ECE/TRANS/WP.29/2007/33
5 April 2007

Proposal for Supplement 6 to the 02 series of amendments to Regulation No. 51
(Noise emissions)

Submitted by the Working Party on Noise

Figure 2: Reference point"

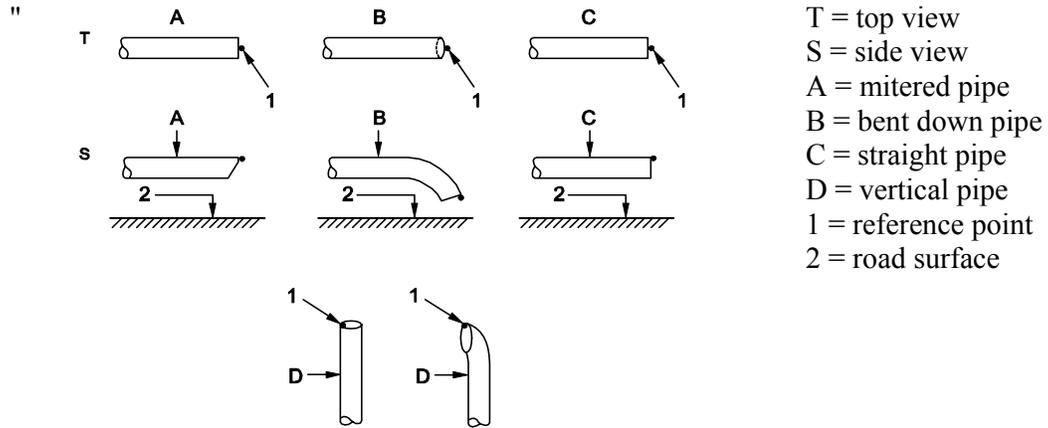
Annex 3 - Appendix, insert a new figure 2 to read:

3.2.5.3.1.1. The microphone shall be located at a distance of 0.5 m \pm 0.01 m from the reference point of the exhaust pipe defined in figure 2 and at an angle of 45 ° (\pm 5 °) to the vertical plane containing the flow axis of the pipe termination. The microphone shall be at the height of the reference point, but not less than 0.2 m from the ground surface. The reference axis of the microphone shall lie in a plane parallel to the ground surface and shall be directed towards the reference point on the exhaust outlet.

- 3.2.5.3.1.4. For vehicles with a vertical exhaust (e.g. commercial vehicles) the microphone shall be placed at the height of the exhaust outlet. Its axis shall be vertical and oriented upwards. It shall be placed at a distance of $0.5 \text{ m} \pm 0.01 \text{ m}$ from the exhaust pipe reference point as defined in figure 2, but never less than 0.2 m from the side of the vehicle nearest to the exhaust.

Figure 3a

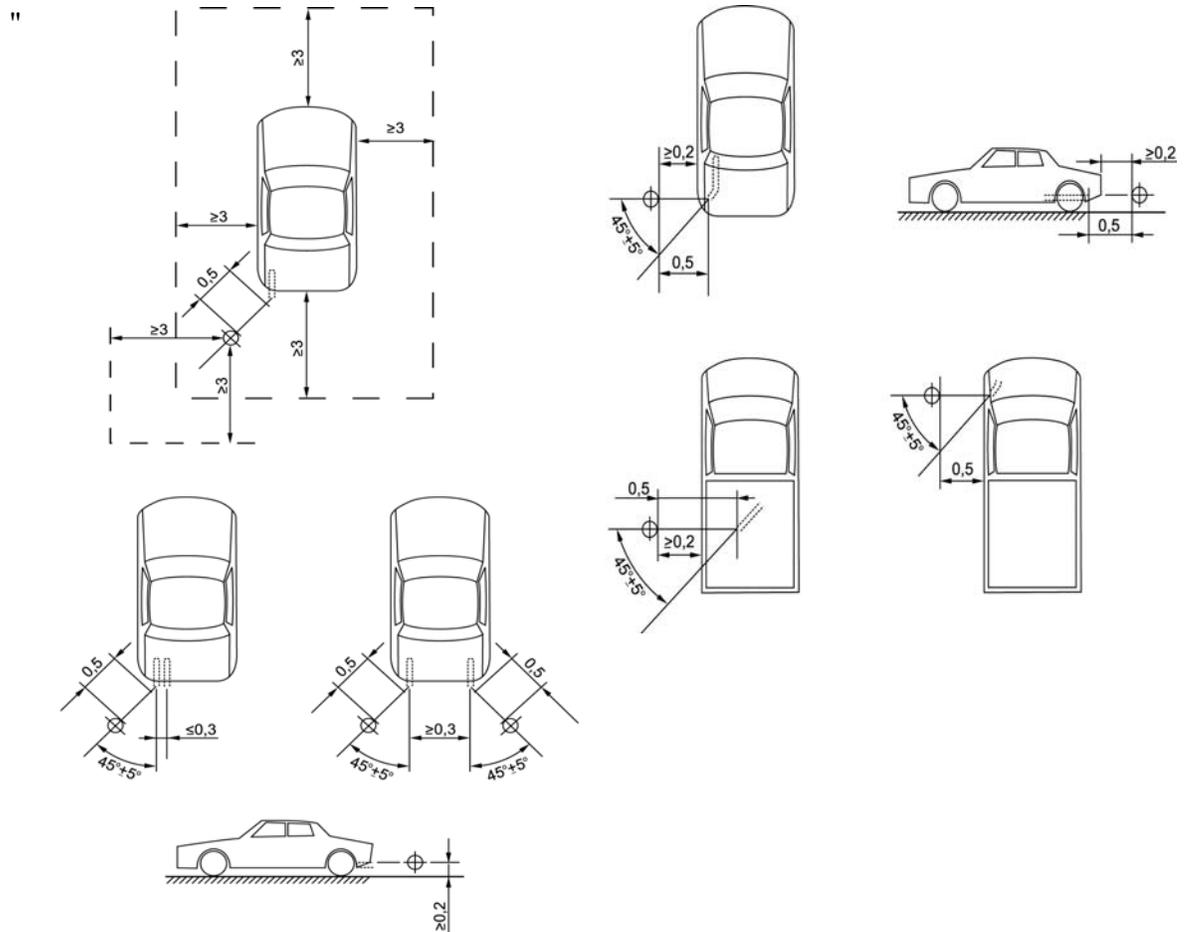
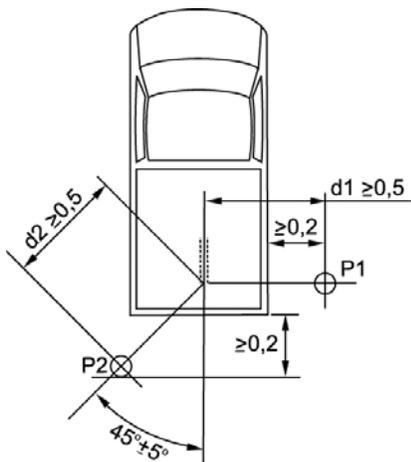
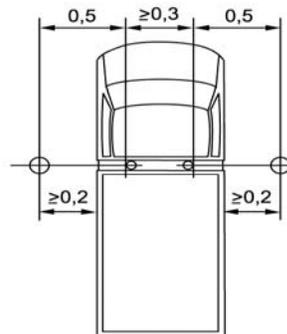
Annex 3 - Appendix, figure 2 (former), renumber as figures 3a to 3d and amend to read:

- 3.2.5.3.1.5. For vehicles, where the reference point of the exhaust pipe is not accessible, or located under the vehicle body, as shown in figures 3b and 3c, because of the presence of obstacles which form part of the vehicle (e.g. spare wheel, fuel tank, battery compartment), the microphone shall be located at least 0.2 m from the nearest obstacle, including the vehicle body, and its axis of maximum sensitivity shall face the exhaust outlet from the position least concealed by the above mentioned obstacles.

When several positions are possible, as shown in figure 3c, the microphone position giving the lowest value of d_1 or d_2 shall be used.

Note: Figures 3a to 3d show examples of the position of the microphone, depending on the location of the exhaust pipe."
